TO: Casey Adragna, Adragna Architecture
FROM: Amber Wood Hicken, Planner I
DATE: 5/5/25
SUBJECT: Douglas 234 Multitenant, Site Plan
Review Comments 01

SITE PLAN
HORSE CREEK COMMERCIAL
 LOT 10B, DOUGLAS 234 FILING NO. 6, AMENDMENT 2
 A PORTION OF THE SW 1/4, SE 1/4, SECTION 29, T6S, R66W, 6TH P.M.
 TOWN OF PARKER, COUNTY OF DOUGLAS, STATE OF COLORADO

LANDSCAPE PLAN
DOUGAS 234 FILING NO. 6, AMD. 2
DATE: FEBRUARY 12, 2025
SHEET L 1

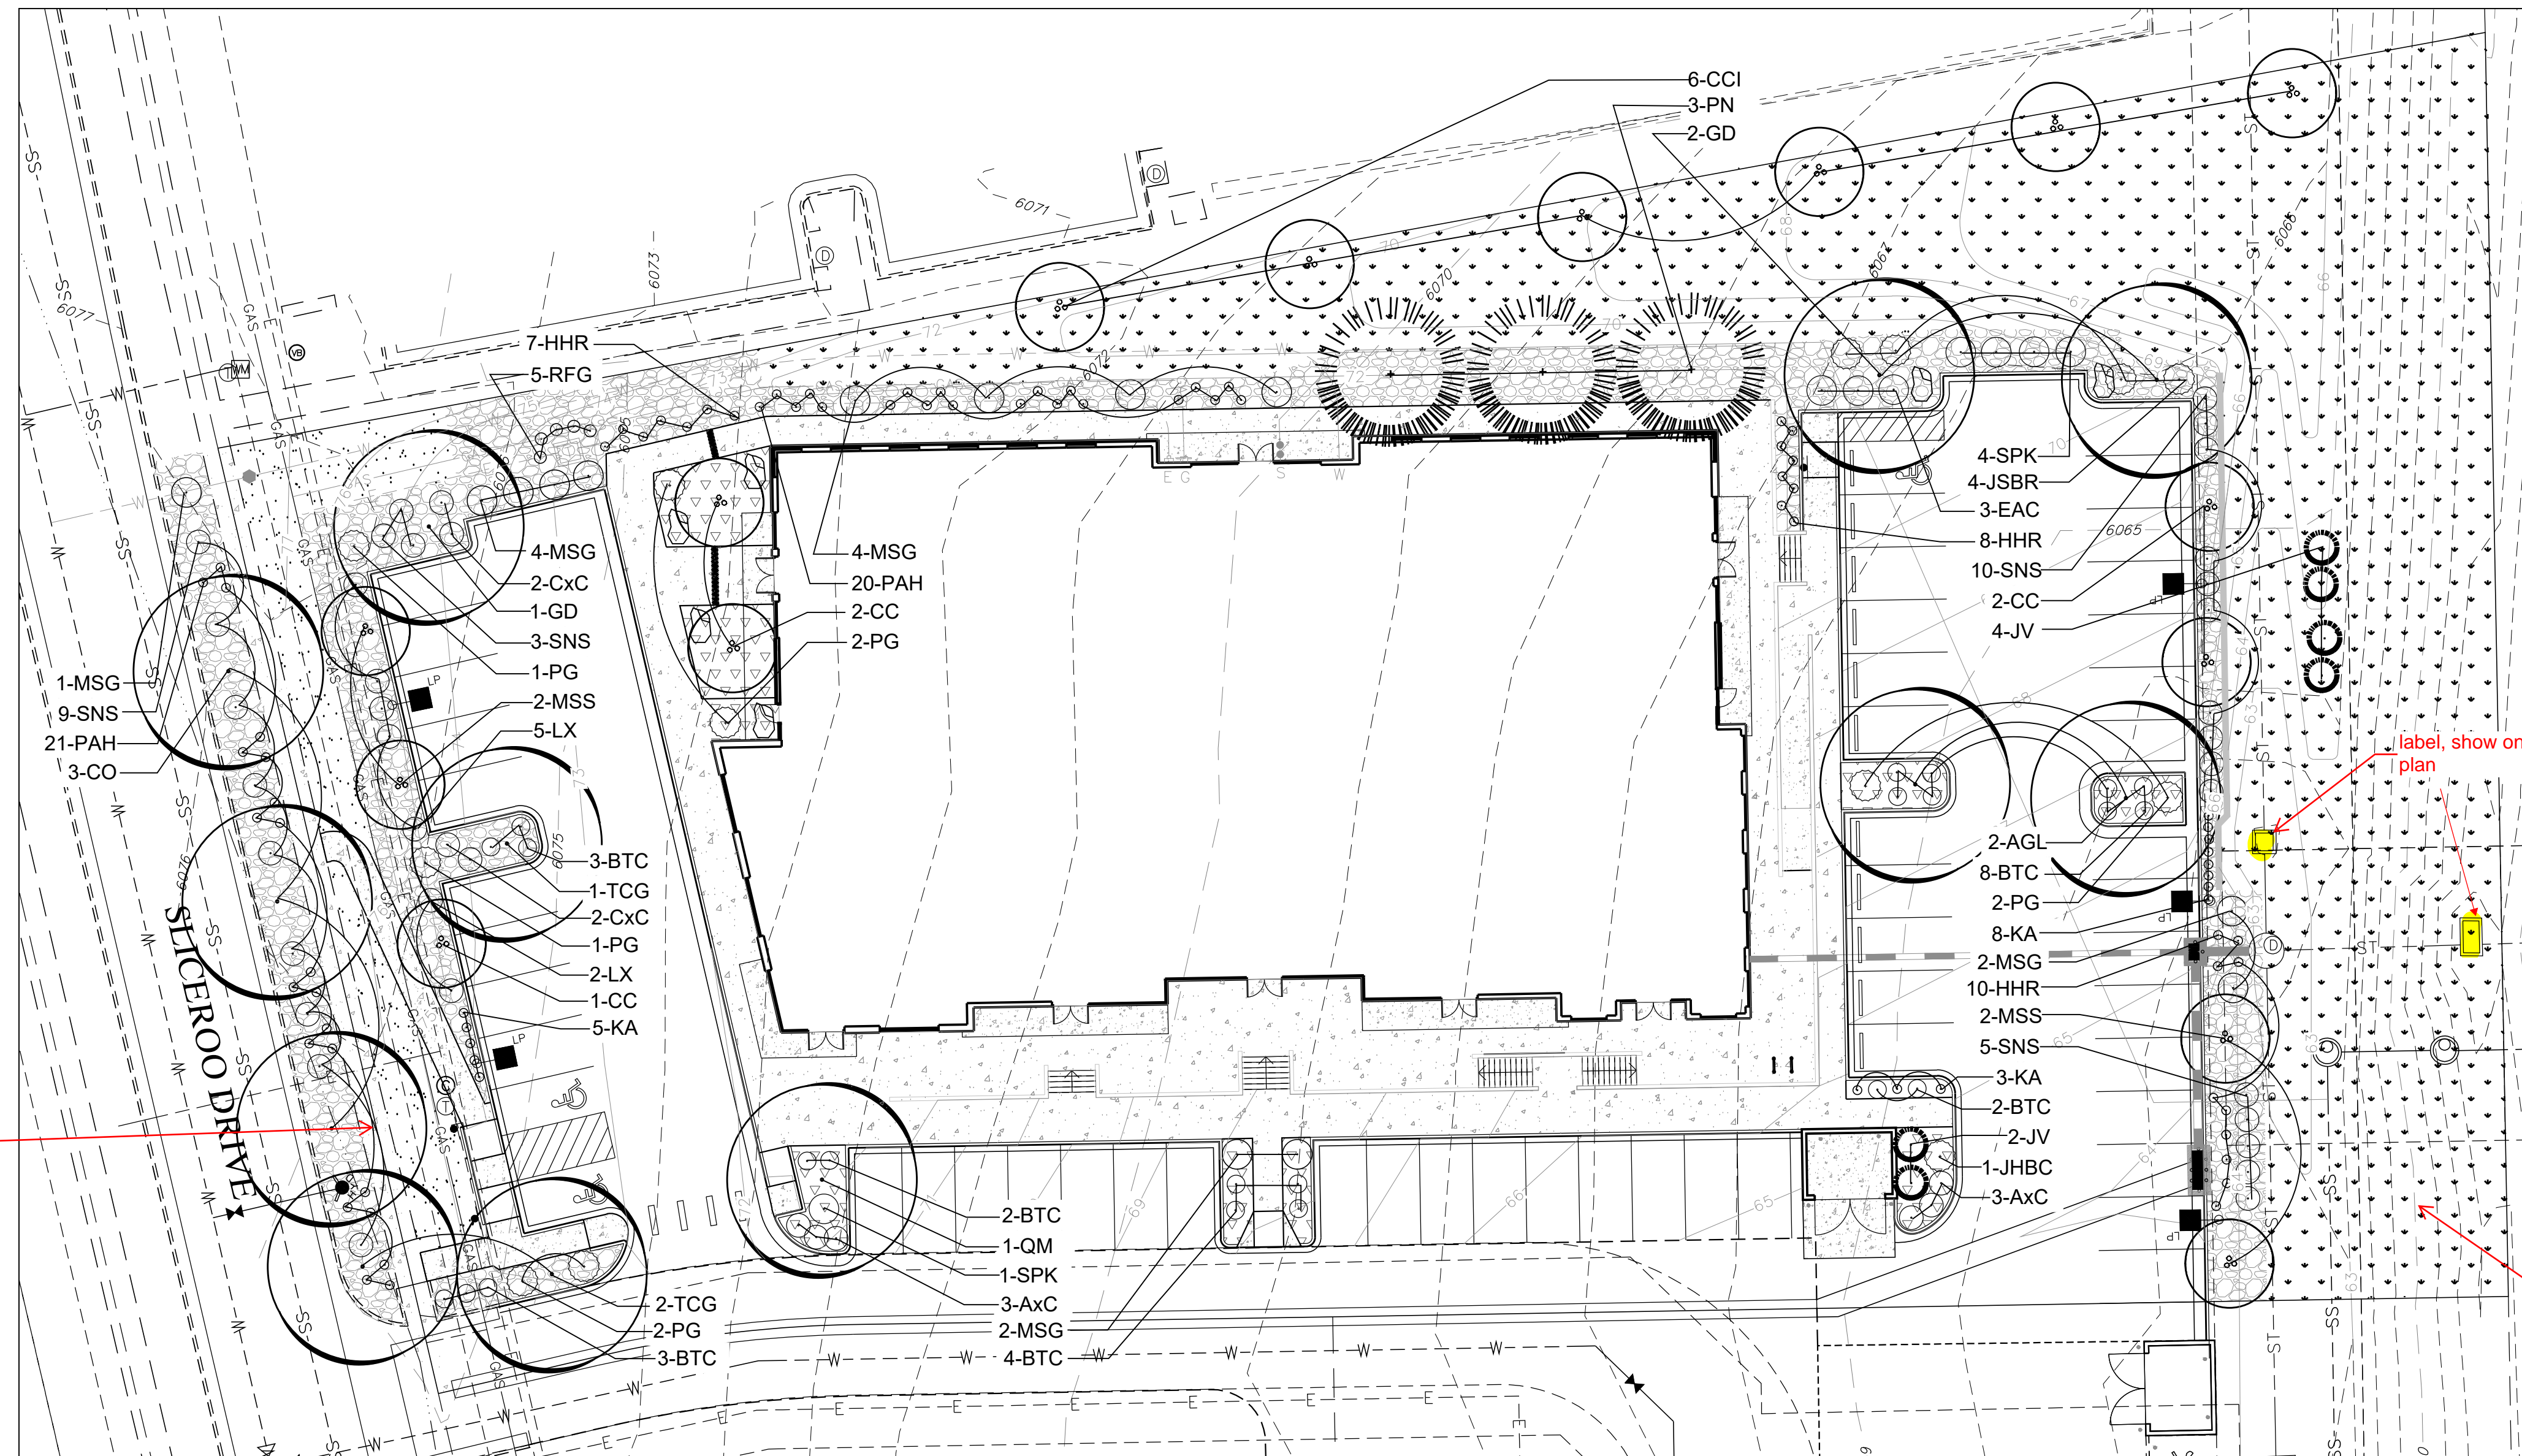
landscaping will need to be enhanced to meet P3 requirements

show limits of sidewalk with solid lines

calculations based off amount of LS provided.

19 trees, 95 shrubs

grasses may substitute for shrubs (One ornamental grass in a five-gallon container or three ornamental grasses in one-gallon containers may be substituted for one shrub)

perimeter landscaping applies to all sides except south. show buffer widths, tree/shrub count requirements

north - P1
east - P3 (fence, evergreen requirements)
west - P2 (parking lot adjacent to ROW)

parking lot interior landscape table needed. break out LS islands, show square footage and tree/shrub requirements. 10% of parking lot must be landscaped.

cover sheet shows 23,768sf of landscaping

plant schedule shows 36 trees, 89 shrubs

show 75% required (% and sq footage)

calculation based off living material (7,704)

1155sf max

SITE PHOTOMETRIC PLAN
 DOUGAS 234 FILING NO. 6, AMD. 2
 DATE: FEBRUARY 17, 2025
 SHEET LT1

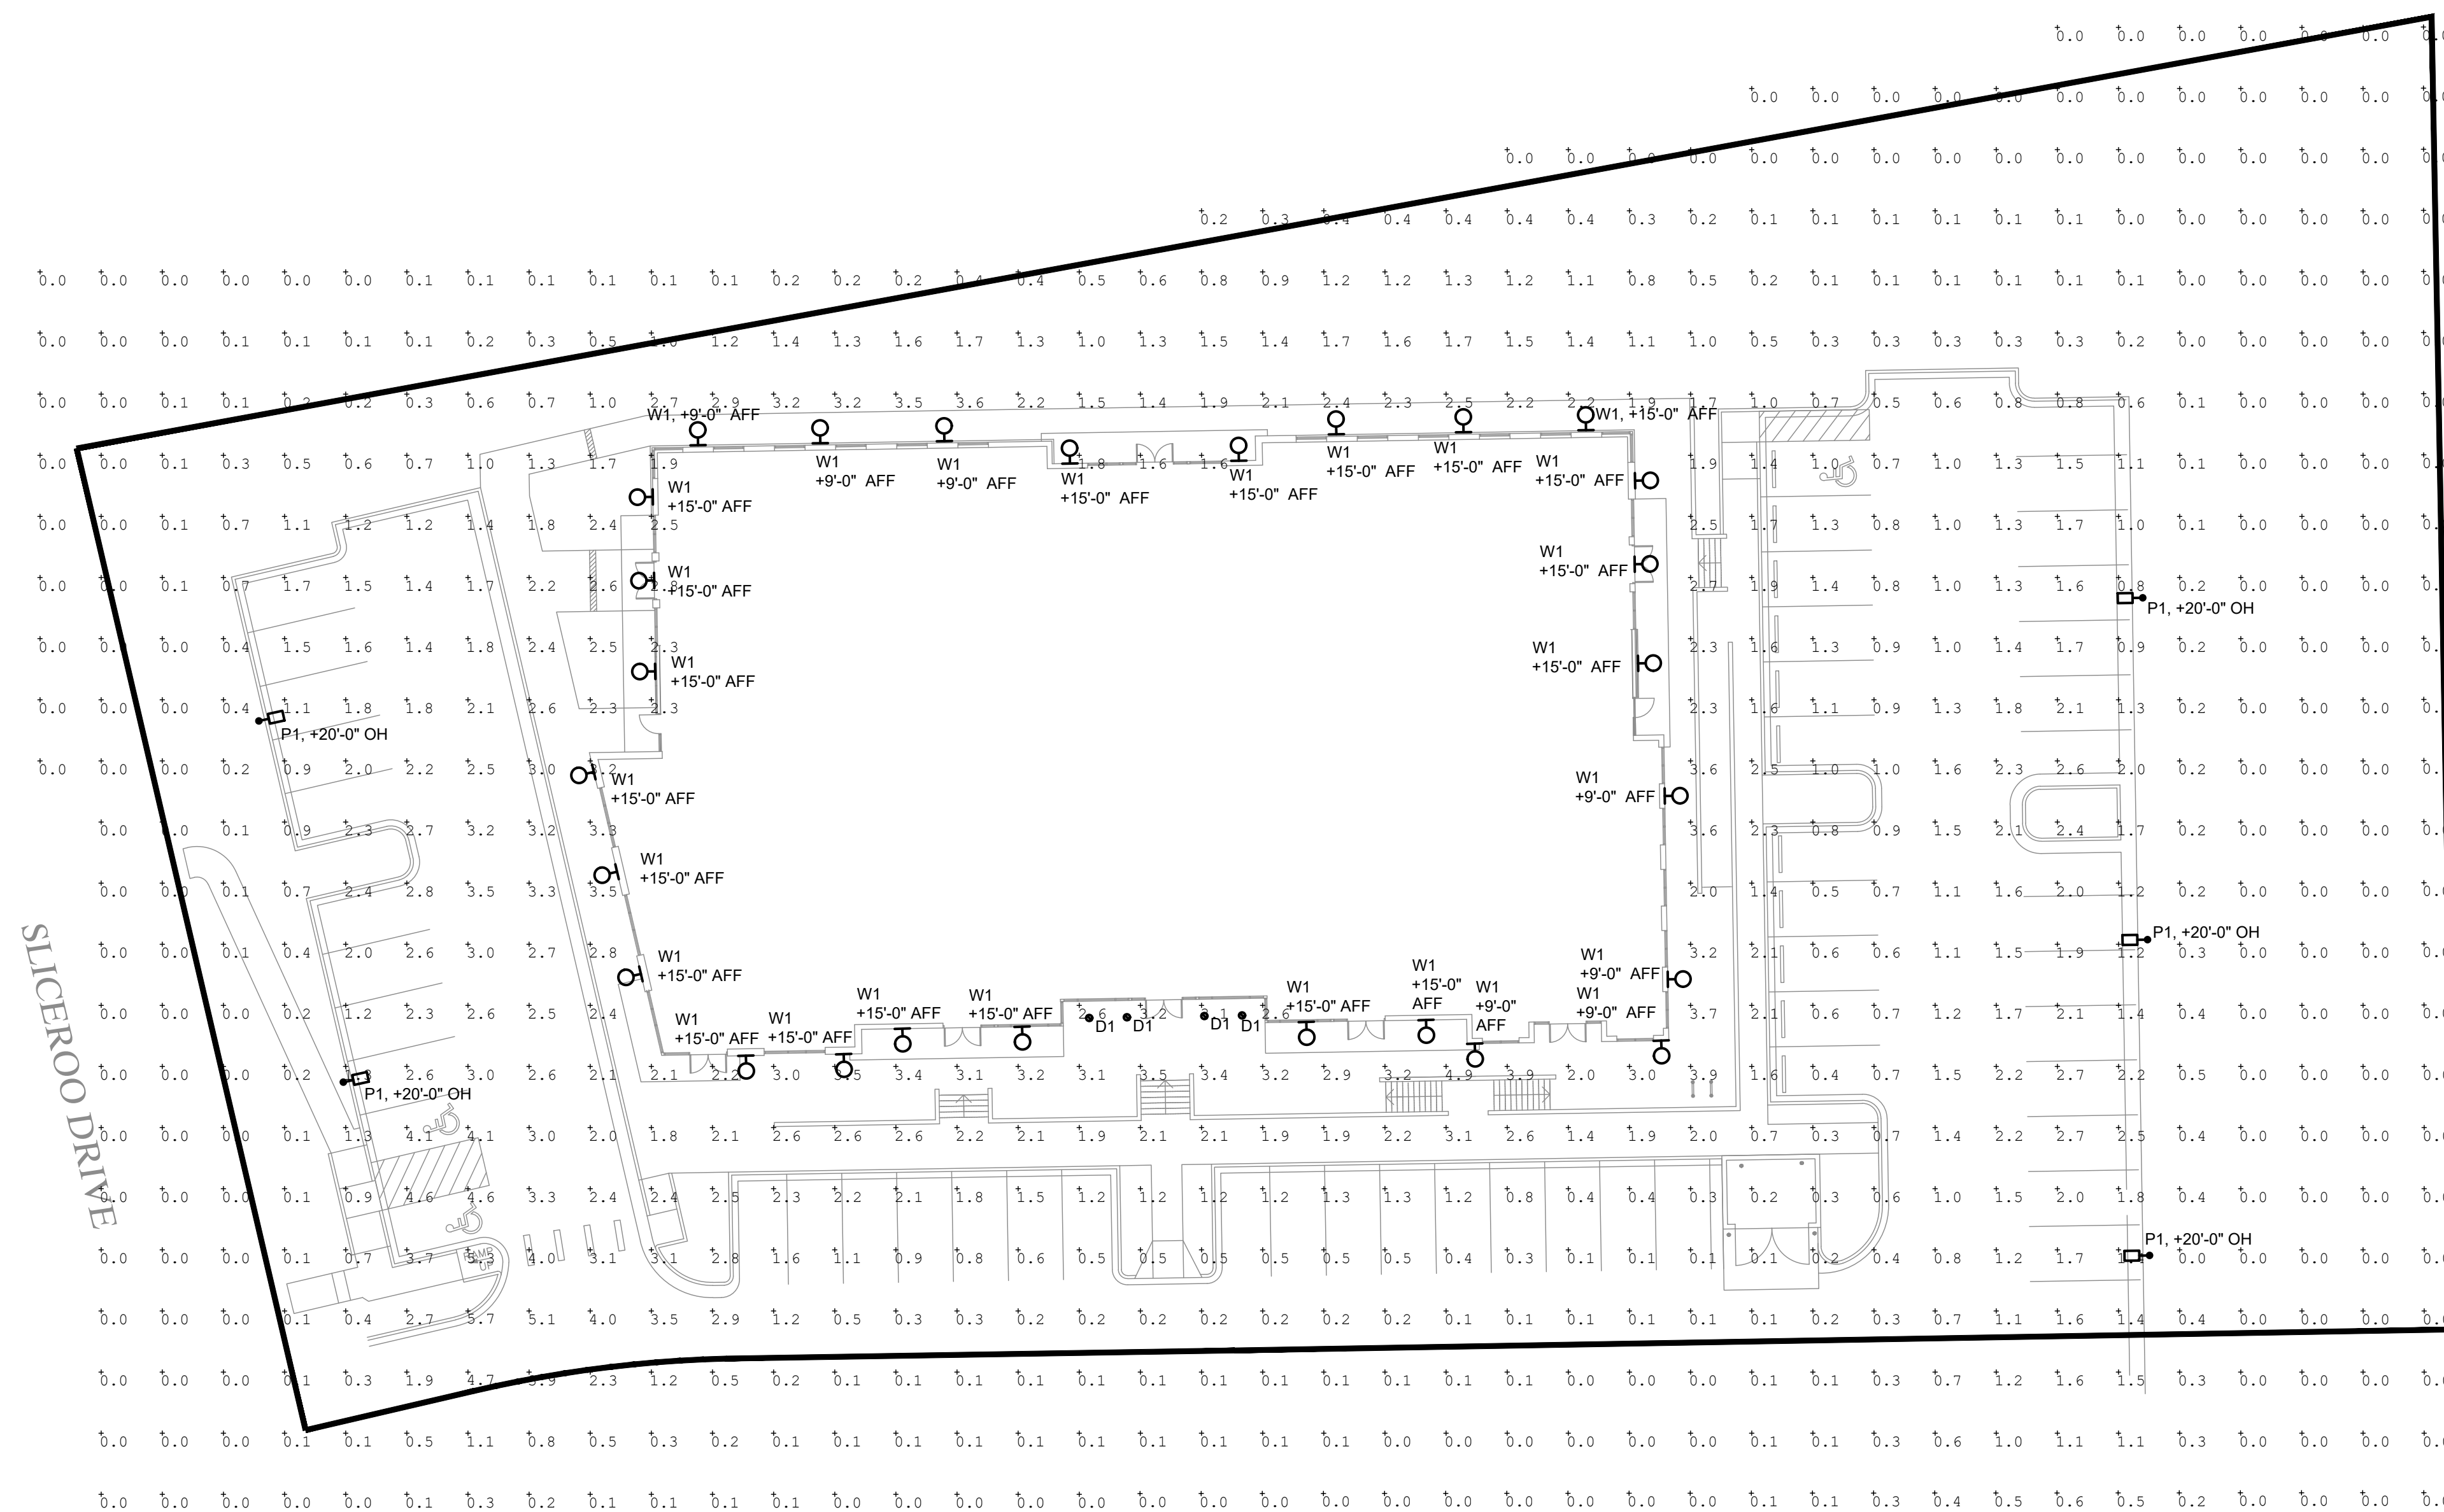
add heights of
mounts/poles

add pole color

All freestanding light fixtures shall be set back from each property line a distance at least equal to the total height of the luminaire.
 provide setbacks from poles to property lines

EXTERIOR ELEVATIONS
 DOUGAS 234 FILING NO. 6, AMD. 2
 DATE: FEBRUARY 17, 2025

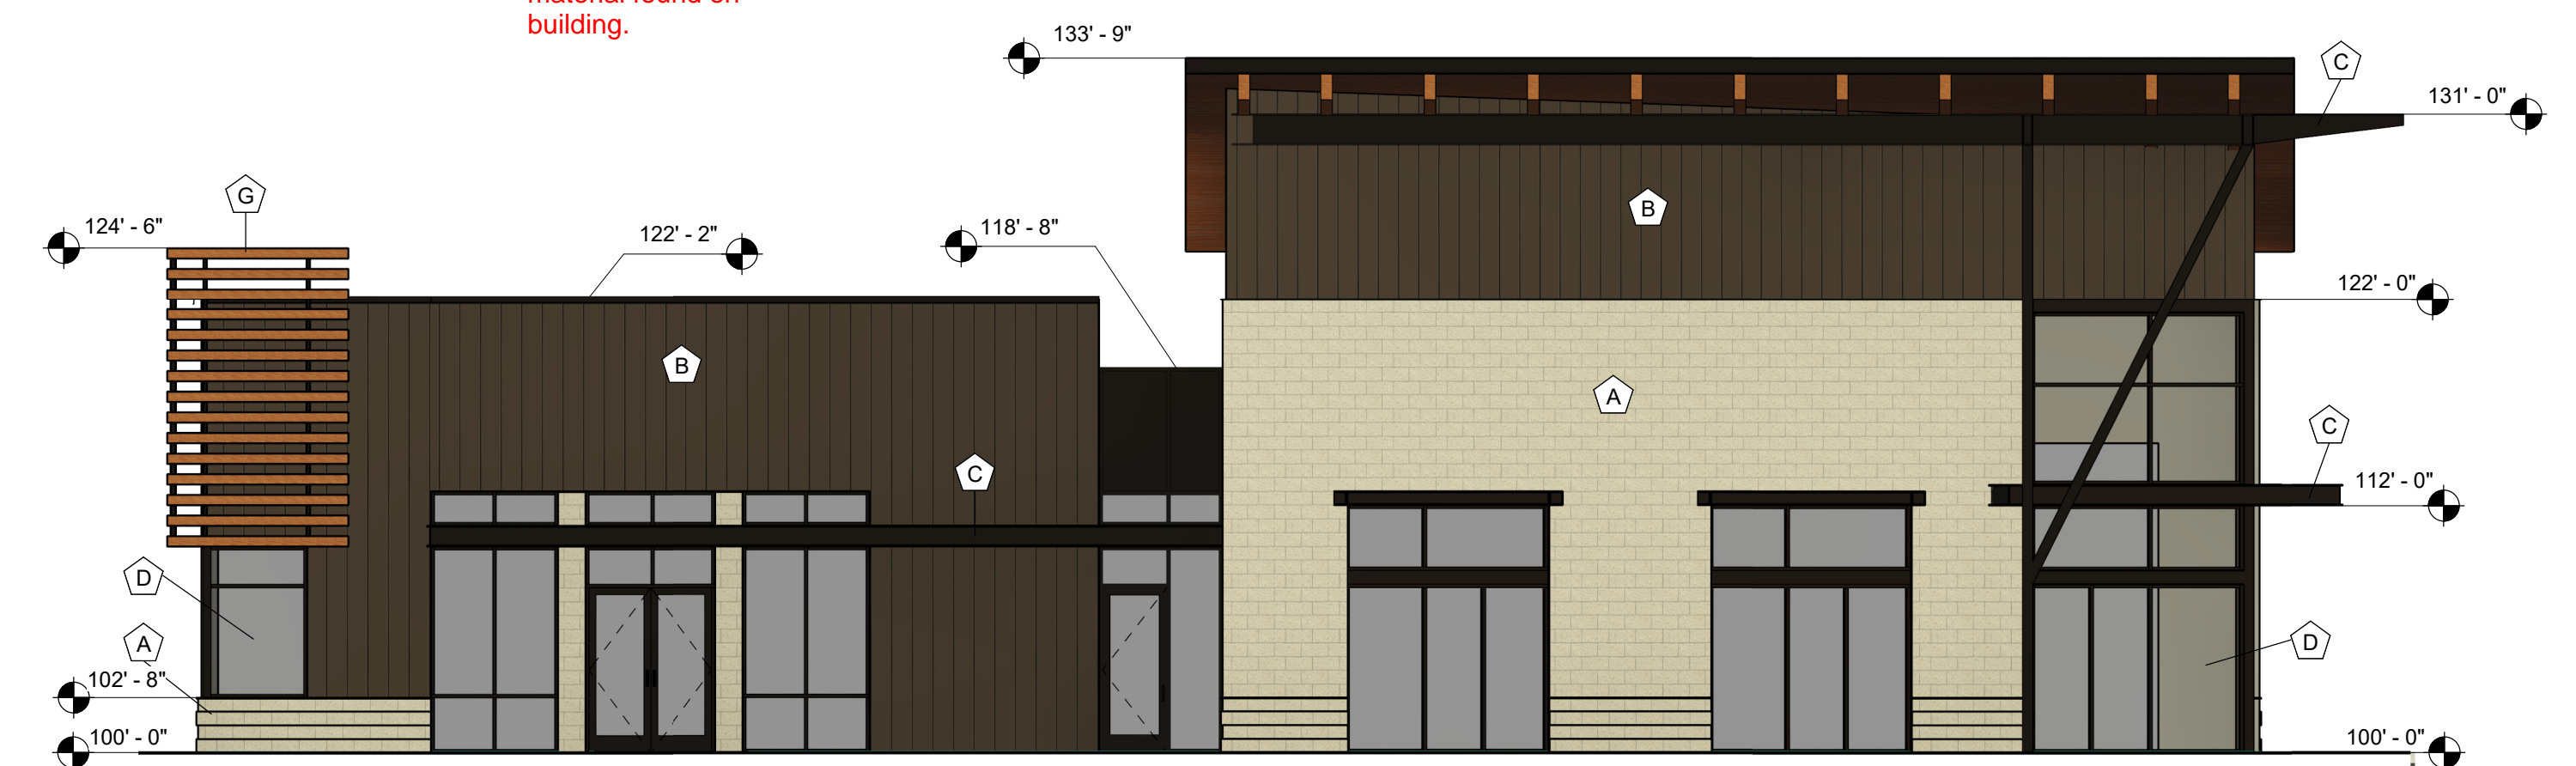
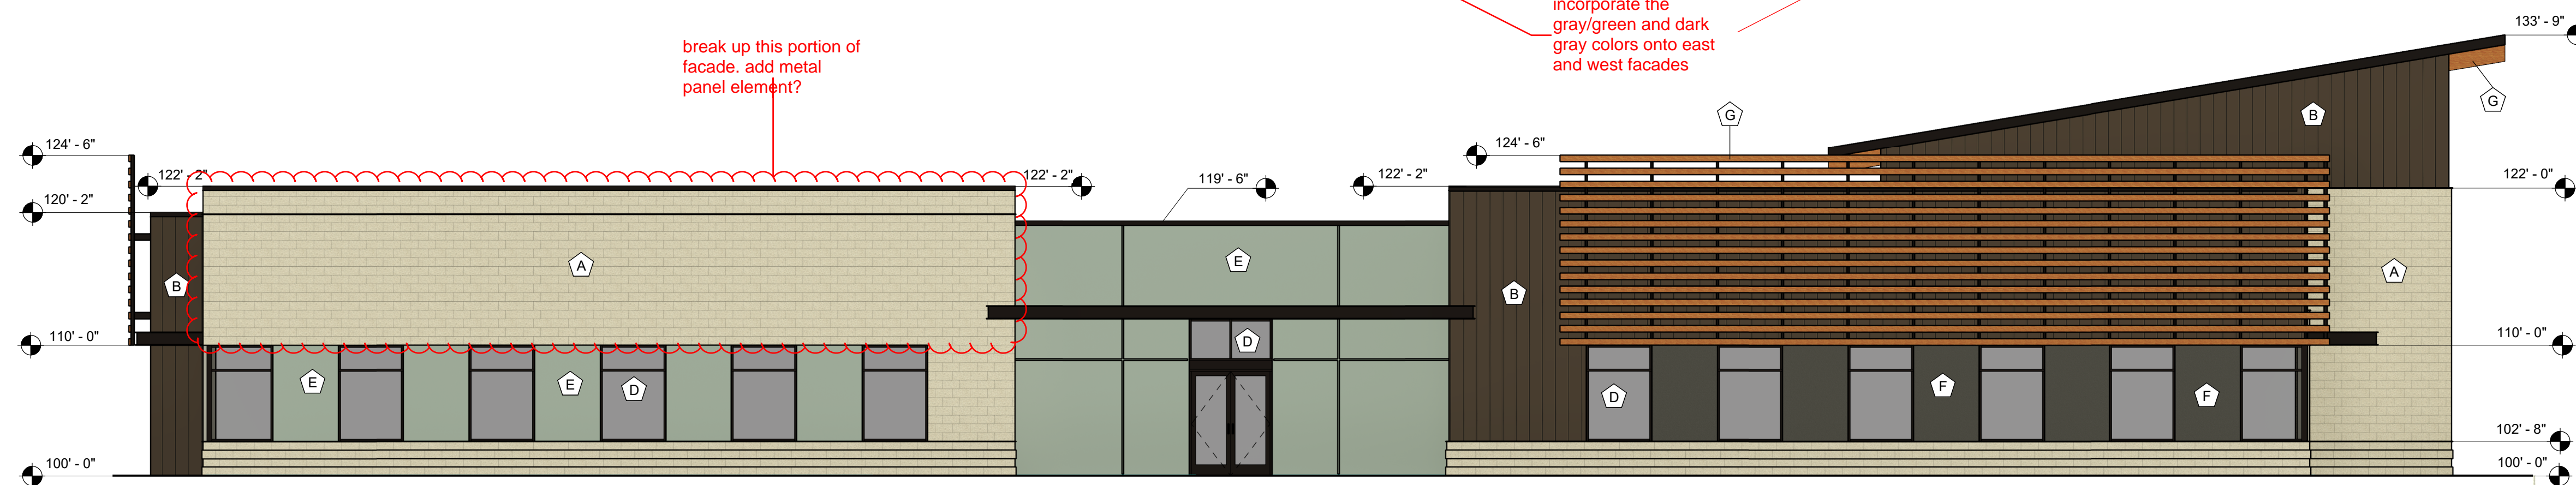
provide transparency calculations on all facades. measured between 2'-8" applies as follows:

north - 25%
 east - 25%
 south - 30%
 west - 30%

stucco can only make up 30% of a facade. provide percentage/square footage

building height is measured from grade
